By letter dated October 8, 1971, you submitted Proposed Change No. 7 to the Technical Specifications appended to Provisional Operating License No. DR-15 for the Southwest Experimental Fast Oxide Reactor. The proposed change would modify the Technical Specifications to reflect the organization changes in the SEFOR management structure and interrelated site supervisory responsibilities.

Change No. 8
License No. DR-15

CHANGE NO. 8 TO THE TECHNICAL SPECIFICATIONS

PROVISIONAL OPERATING LICENSE NO. DR-15

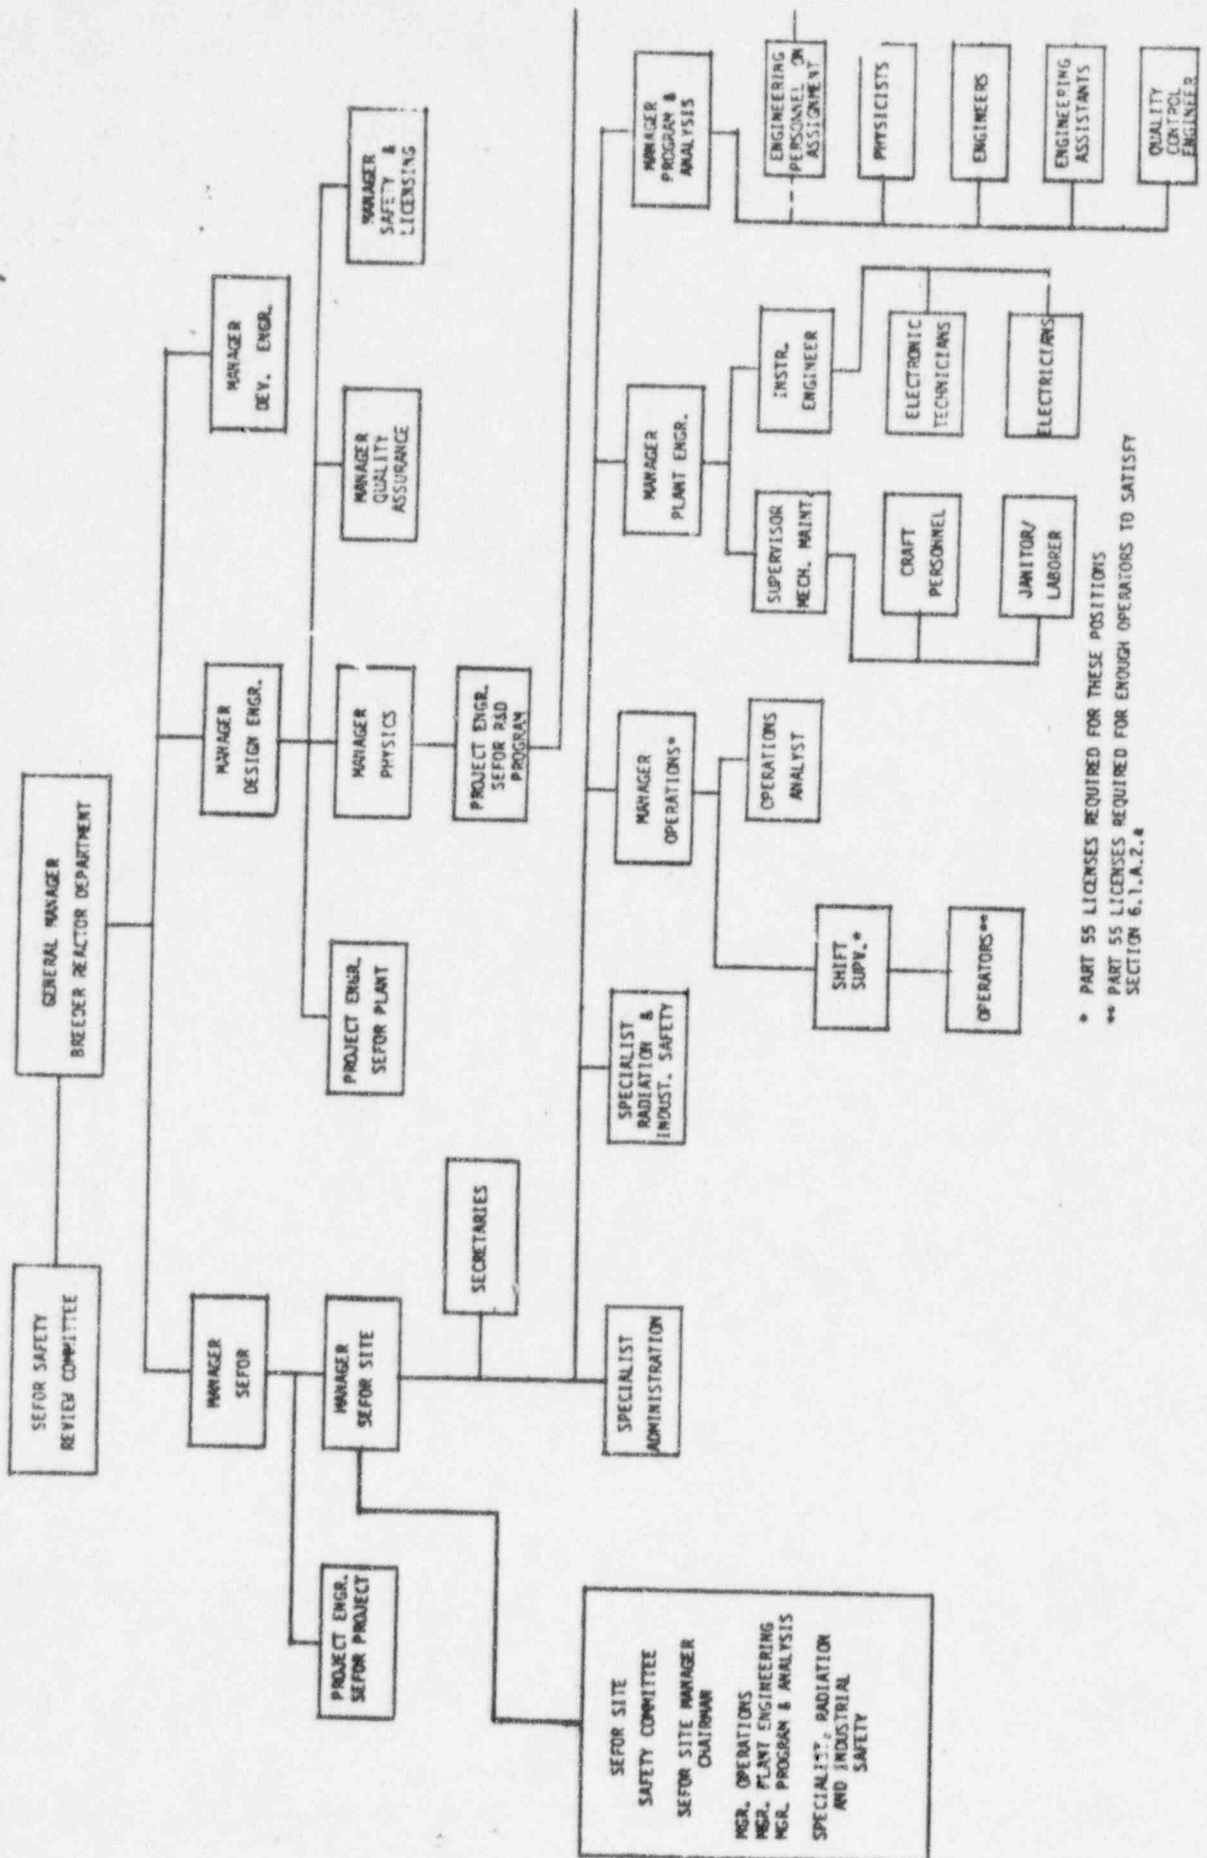
1. The organization for management, operation, and audit of SEFOR facility operations shall be as given in Figure 6-1. The overall full-time responsibility for operation of the SEFOR facility and compliance with these Technical Specifications shall reside in the SEFOR Site Manager. The Site Manager reports to the Manager, SEFOR, who in turn is responsible directly to the BRD General Manager. The BRD General Manager reports to the Nuclear Energy Division General Manager. As indicated in Figure 6-1, technical engineering assistance will be provided as necessary through the BRD Manager of Design Engineering.

- d. Personnel requiring Part 55 licenses shall be as indicated in Figure 6-1.
- 3. Qualifications with regard to education and operating experience for key supervisory personnel shall be as follows:
 - a. Manager, SEFOR Site
